**ADDENDUM NO. 1**  
**TO CONTRACT DOCUMENTS FOR THE**  
**UPPER GUADALUPE RIVER REACH 6 AQUATIC HABITAT IMPROVEMENT PROJECT**  
**Project No. 26154002 Contract No. C0660**

**ADDENDUM NO. 1**  
**Santa Clara Valley Water District**  
**C0660 – Upper Guadalupe River Reach 6 Aquatic Habitat Improvement Project**

# MAP AND CONSTRUCTION PLAN FOR UPPER GUADALUPE RIVER REACH 6 AQUATIC HABITAT IMPROVEMENT PROJECT

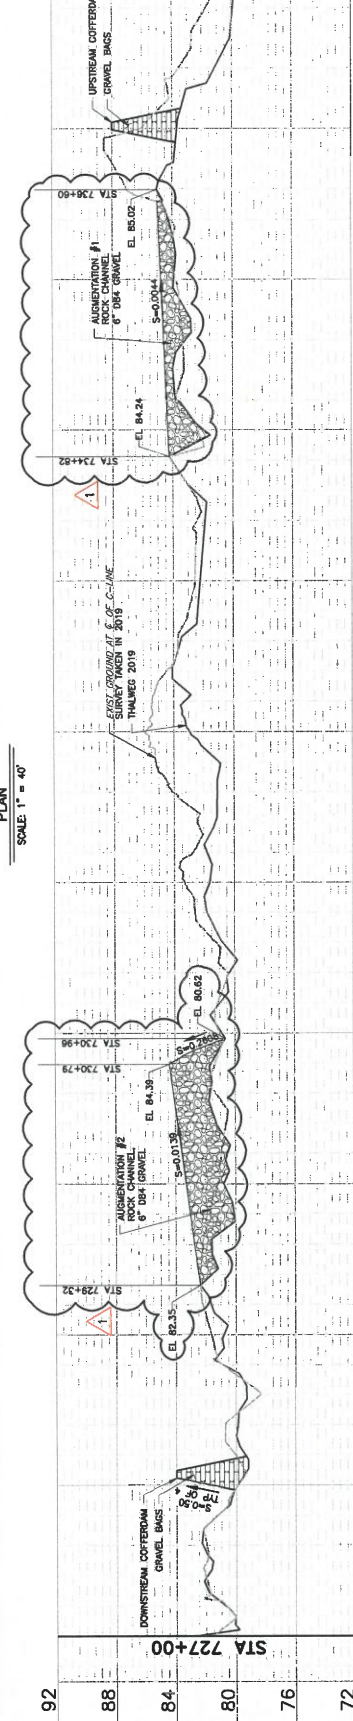
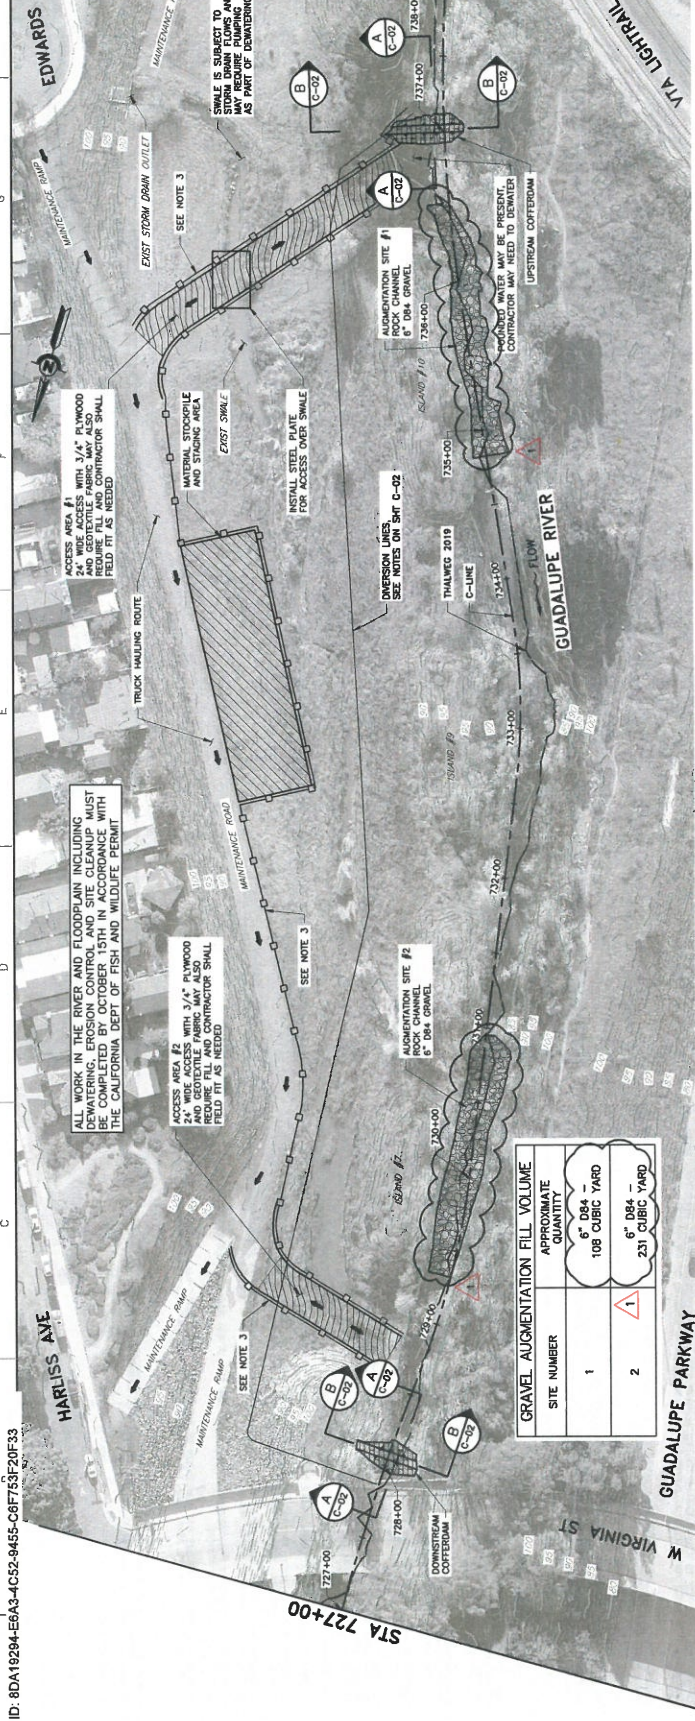
Regarding the homeless encampment mentioned on plan page G-02 General Notes #24 as follows:

What is the standard of cleanliness that is established to ensure that the Contractor's employees are not put at risk if the extent of cleanup is not at a satisfactory level to ensure the health & safety of our employees?

4. On Sheet G-02, Note 9 states that the "Contractor shall install 6' high temporary chain link fence with green screen around the construction area where the public may be affected". Are you expecting the entire job site along the access road to require fencing to screen it from the housing? We have assumed the temp fencing to screen only the staging area so please clarify if our assumption is acceptable or if there are other potentially affected areas that may require temp fencing.

Valley Water doesn't have a standard of cleanliness but the current practice has been that any homeless encampments that directly impact work progress can be abated and our crews will remove all debris and any objects that could harm workers. However, due to the Covid 19 concerns, if the homeless encampment isn't within the future work footprint, then the homeless people would be moved out of the area but their belongings would not be removed.

3. The Contractor's attention is directed to Article 23.07 Erosion Control Blanket for application of erosion control blankets.
4. Temporary fencing is intended to protect the public from harm or injury in any area where the Contractor intends to store equipment while the Contractor is away from the site. This could be either in the public right of way or in the District's right of way. If the Contractor intends to store equipment in the staging area then that would be an area to provide temporary fencing.
